Project	<b>IEEE 802.16 Broadband Wireless Access Working Group</b> < <a href="http://ieee802.org/16">http://ieee802.org/16</a> >	
Title	<b>Enhancement of STC/MIMO Pilots</b>	
Date Submitted	<b>2004-09-01</b> <del>08-17</del>	
Source(s)	Jing Wang Sean Cai Jason Hou Jun Han Dazi Feng	<a href="mailto:jwang@ztesandiego.com">jwang@ztesandiego.com</a> <a href="mailto:scai@ztesandiego.com">scai@ztesandiego.com</a> <a href="mailto:jhou@ztesandiego.com">jhou@ztesandiego.com</a> <a href="mailto:jhan@ztesandiego.com">jhan@ztesandiego.com</a> <a href="mailto:dfeng@ztesandiego.com">dfeng@ztesandiego.com</a>
	ZTE San Diego Inc. 10105 Pacific Heights Blvd. San Diego, CA 92121 USA	Voice: 858-554-0387 Fax: 858-554-0894
Re:	STC/MIMO Pilots Enhancement	
Abstract	Proposing new STC/MIMO pilot structure for IEEE P802.16e/D5-2004	
Purpose	To enhance STC/MIMO performance	
Notice	This document has been prepared to assist IEEE 802.16. It is offered as a basis for discussion and is not binding on the contributing individual(s) or organization(s). The material in this document is subject to change in form and content after further study. The contributor(s) reserve(s) the right to add, amend or withdraw materi

Fig. 5 Proposed pilots scheme for STC/MIMO 2 antenna systems

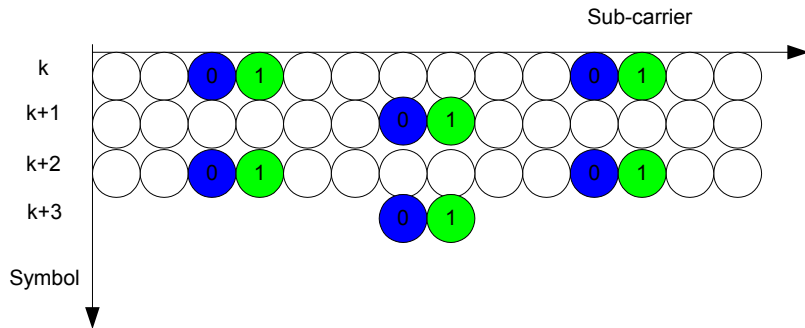
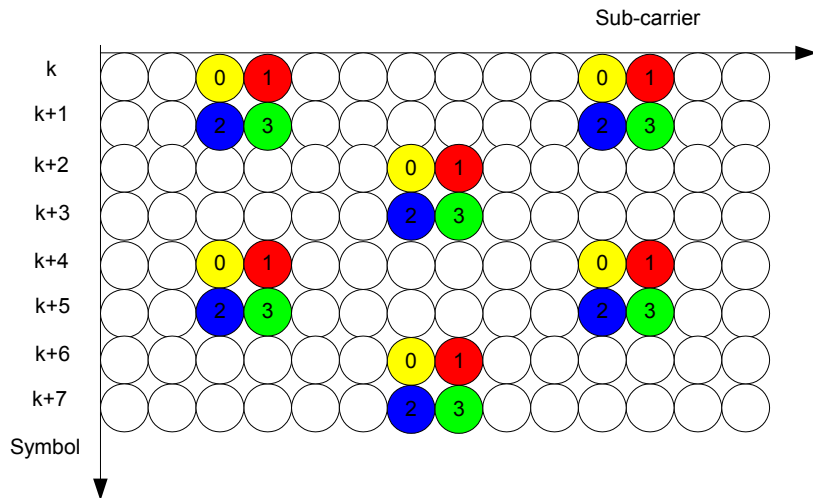
In PUSC mode, we propose an improved pilot allocation for two and four antennas, respectively, in Figure 5 and 6. Color definition: white and colored circles represent data and pilots, respectively.

The overhead for the proposed pilot set is the same for two and four antennas, about 20%. In comparison with the original ones, the overhead is about 14% and 28% for two and four antennas, respectively.

Fig. 7 Proposed pilots scheme for STC/MIMO 2 antenna systems

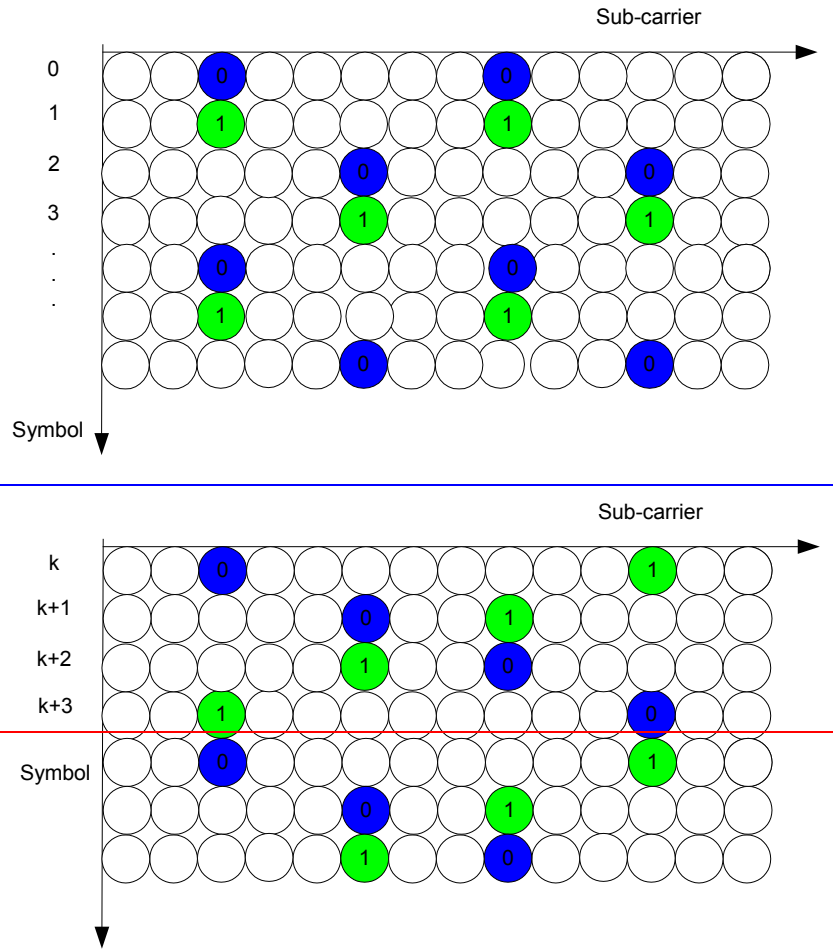
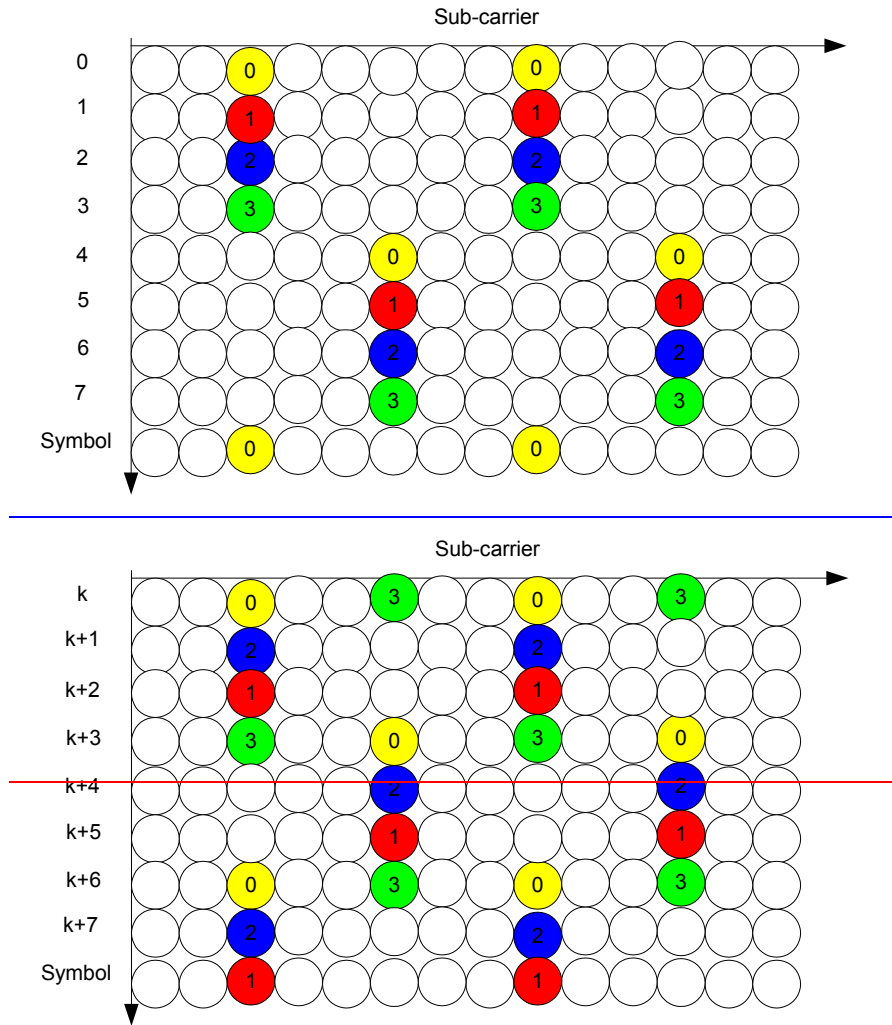
The overhead for the proposed pilot set is the same for two and four antennas, about 20%. In comparison with the original ones, the overhead is about 14% and 28% for two and four antennas, respectively.

Fig. 9 Alternative proposed pilot scheme for STC/MIMO 4 Tx antenna systems. (It can be easily modified for 2 Tx antennas case).

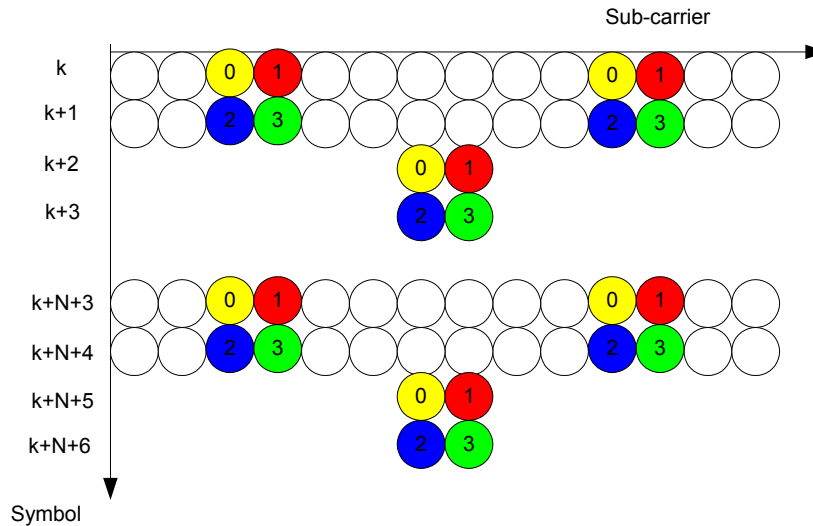
Further overhead reduction is straightforward. One solution is to reduce time domain pilot density, as shown in Figure 9 below.

In Figure 9, the time spacing  $N$  ( $\geq 1$ ) between the pilot sets specifies the overhead; a larger  $N$  results in a lower overhead but reduces its effectiveness against time varying channel conditions. Default value of  $N$  is set to 1. If  $N$  is to set greater than 1, a new STC/MIMO IE can be introduced to specify its value.

Fig. 245-Cluster structure (colored circles represent pilots with antenna index 0 and 1)

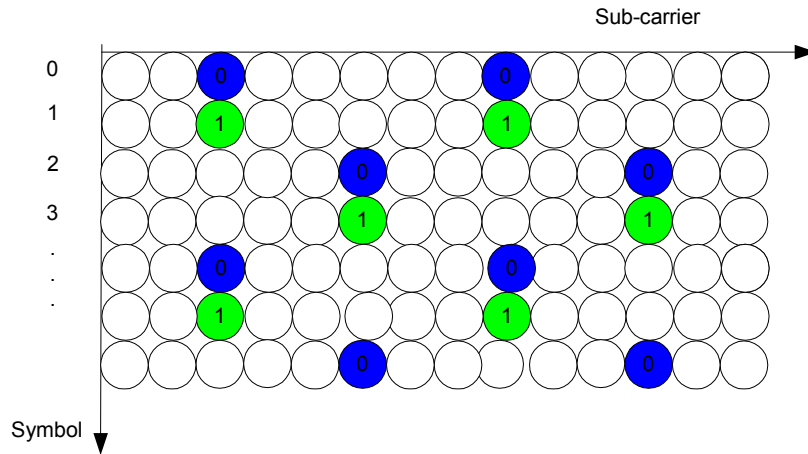
[Add the following text to modify section 8.4.8.1.2.1.1 STC using 2 antennas in PUSC]

The clusters composing the subchannels used by the STC mode shall be allocated and subcarriers numbered as defined in 8.4.6.2. The cluster structure of the subchannels allocated for STC is slightly modified to fit the STC requirements. The structure shall be modified as depicted in Figure 245 (switching 2 pilot carriers ~~from the odd symbol~~ with 2 data carriers ~~from the even symbols~~ at each symbol time, switching of the data carriers and the pilots carriers shall be performed after constellation mapping, therefore maintaining all the encoding scheme and the subchannel allocation scheme). The minimum data burst shall be multiple of 2 symbol periods. In this scheme, transmission on regular subchannels and STC subchannels is possible and is determined by the MAC layer (the allocation is performed by allocating major groups of subchannels for regular or STC transmission). The transmission of the data shall be performed in pairs of symbols as illustrated in Figure 246.

Figure 251 – Cluster structure (colored circles represent pilots with antenna index 0 to 3)

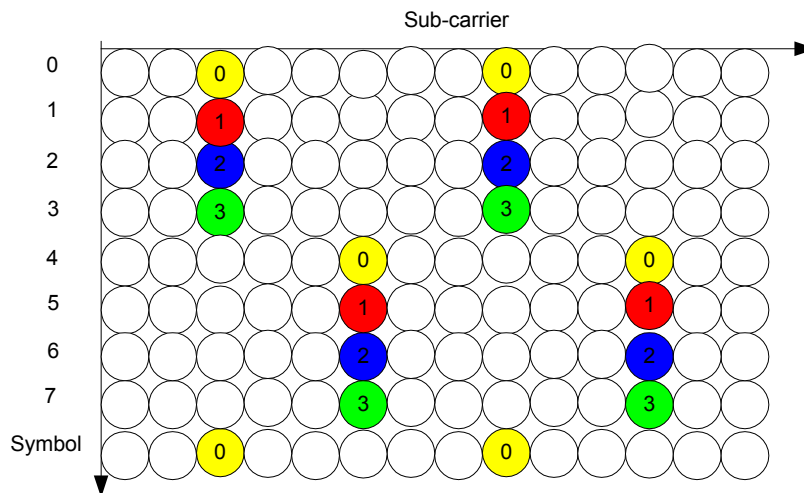
[Add the following text to section 8.4.8.2.1 STC using 4 antennas in PUSC]

~~For~~ For this configuration the basic cluster structure is changed as indicated in Figure 251 to accommodate the transmission from 4 antennas (pilots for antennas 2/3 overrides switch with data subcarriers at every symbol in the even symbols, switching and erasing of the data subcarriers shall be performed after constellation mapping, therefore therefore maintaining all the encoding scheme and the subchannel allocation scheme). The minimum data burst shall be multiple of 4 symbol periods.
